CITY OF CODY
PLANNING, ZONING AND ADJUSTMENT BOARD AGENDA REGULAR
MEETING OF TUESDAY, April 9, 2024 AT 12:00 P.M. (NOON)
CODY CITY HALL COUNCIL CHAMBERS, 1338 RUMSEY AVENUE, CODY, WY

City of Cody
Planning, Zoning, and Adjustment Board Special Meeting
April 2, 2024

**CITY OF CODY
PLANNING, ZONING AND ADJUSTMENT BOARD
STAFF REPORT**

MEETING DATE:	APRIL 2, 2024	TYPE OF ACTION NEEDED	
AGENDA ITEM:		P&Z BOARD APPROVAL:	X
SUBJECT:	SITE PLAN REVIEW: NEW BUILDING AT 1234 SHERIDAN AVENUE. SPR 2024-08	RECOMMENDATION TO COUNCIL:	
PREPARED BY:	TODD STOWELL, CITY PLANNER	DISCUSSION ONLY:

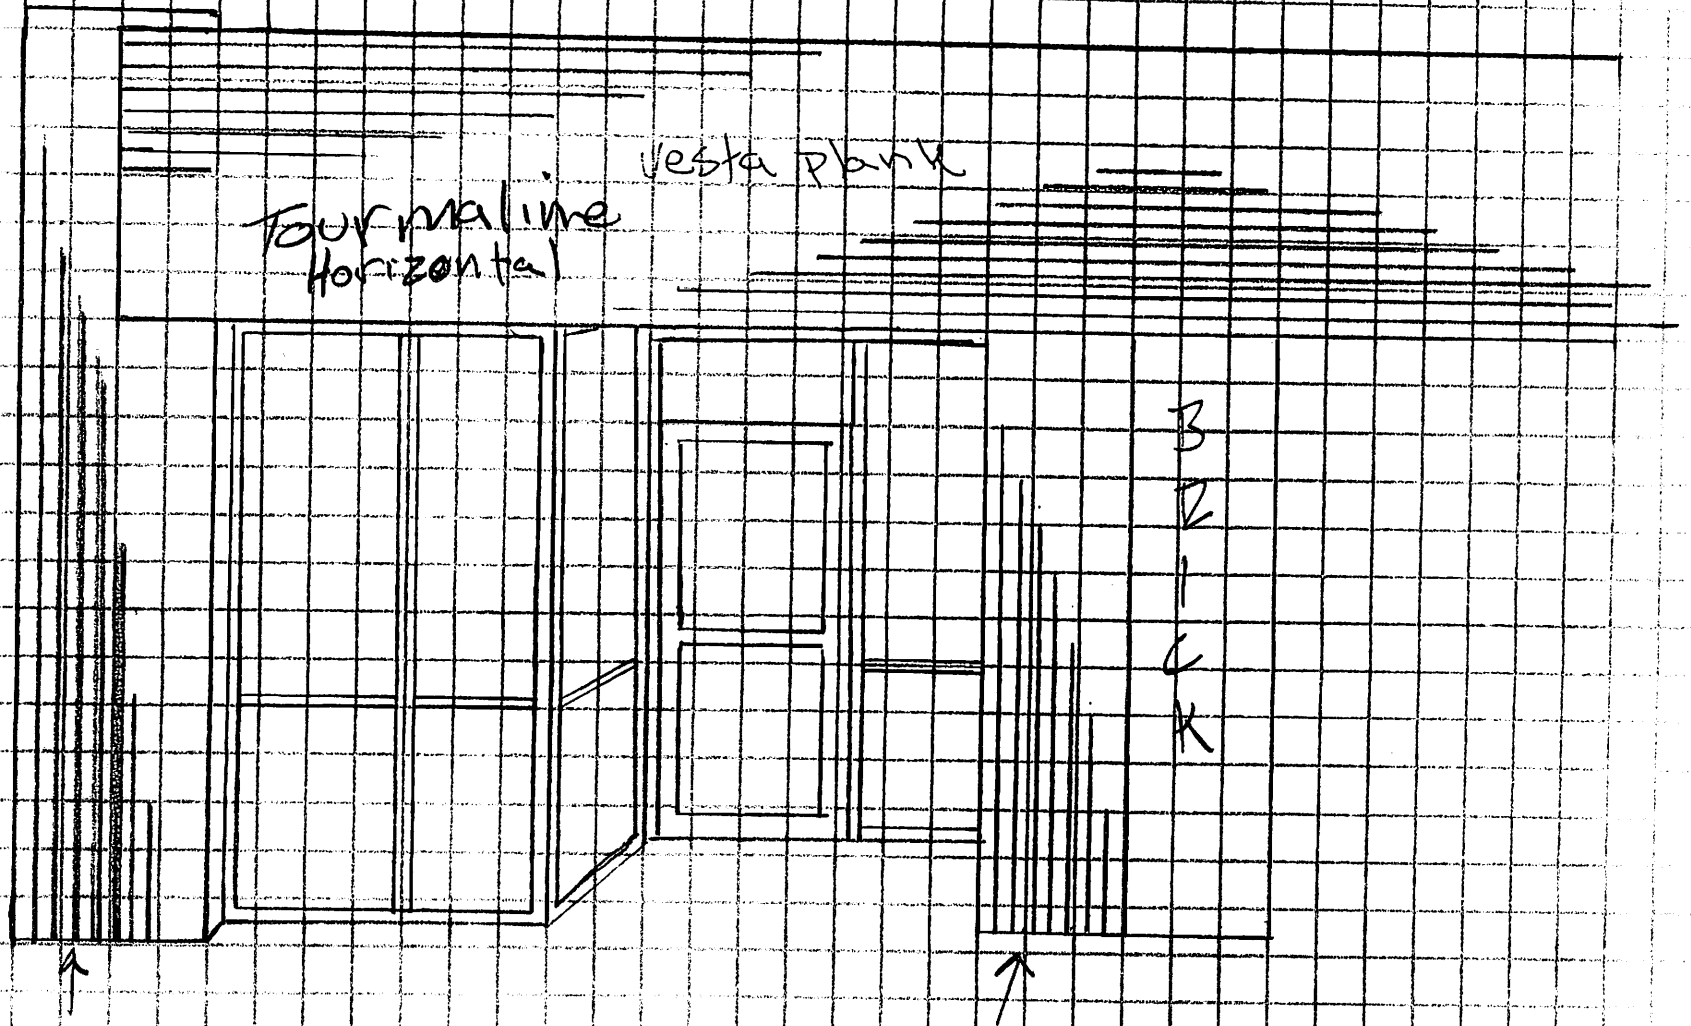
The proposal will replace the diagonal shiplap siding on the exterior of the Domino's restaurant with vertical metal wall panels with a wood pattern. The upper wall/parapet will have its paneling replaced with horizontal metal panels in a * solid color. The storefront windows and brick will remain unchanged. Only the Domino's frontage is being updated at this time—no other business facades on the building are included.

Staff has no concerns with the proposed architectural changes. The colors match well with each other, the existing brick, and the sign that will remain. The metal wall panels are quality materials that are being used in commercial buildings. The Wendy's restaurant next door was approved last year to utilize metal panels on their upcoming exterior update (brown wood appearance on parapet).

Sarah Miles made a motion to approve the proposal with the discussed change of the Perling horizontal metal planking to something more consistent with the proposed metal siding in the grey/white family of colors. Motion dies due to lack of a second. Motion fails.

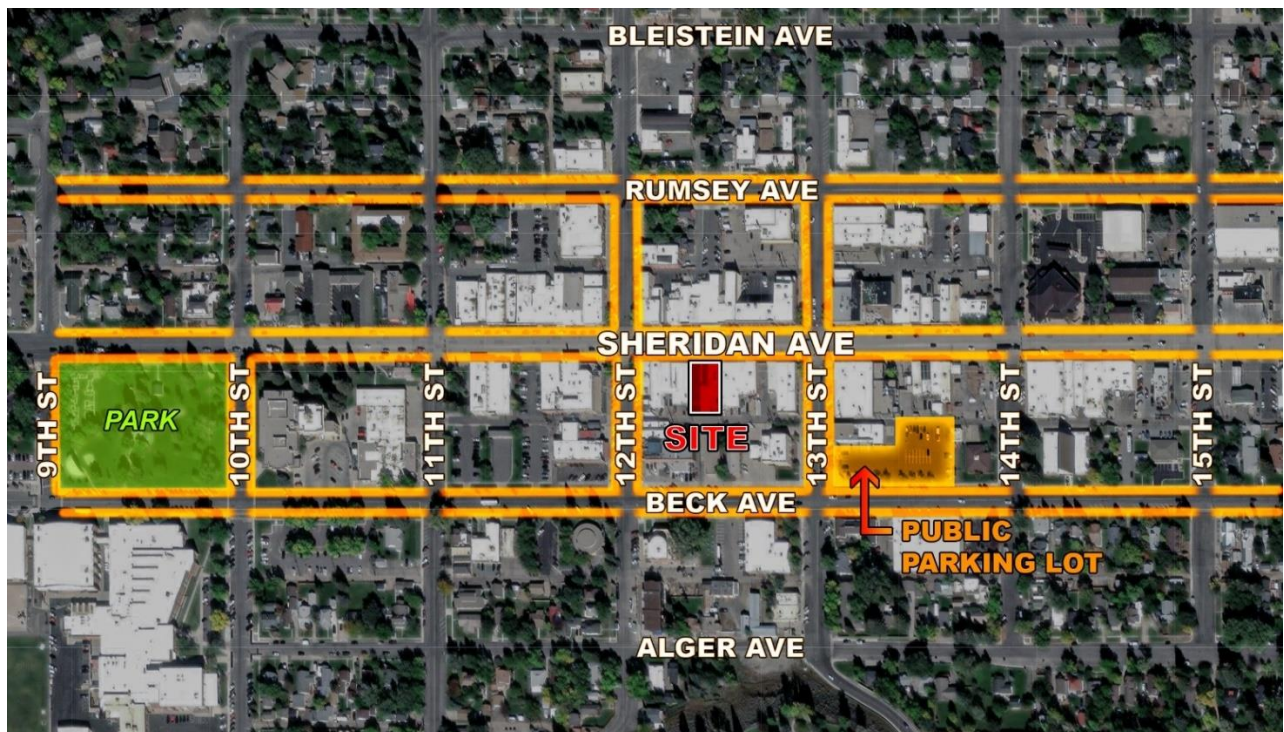
The site plan shows six, 90-degree parking spaces along the back of the building, under the 2nd level. However, ADA standards require at least one ADA parking space, with an unloading area and ADA compliant access to the building. That will mean that the sixth parking spot (the east spot) will be lost in order to accommodate the unloading area. A plan showing the ADA parking space and details to demonstrate ADA compliance is needed.

1. Modify the plans to include the required ADA van-accessible parking space, unloading aisle, and building access. The loss of the one parking space is authorized.
2. Submit engineering plans for the fire line for Public Works review and approval, then submit them to WY DEQ for a permit to construct. The WY DEQ permit is required prior to construction.
3. Verify the domestic water service size with Public Works and the building official.
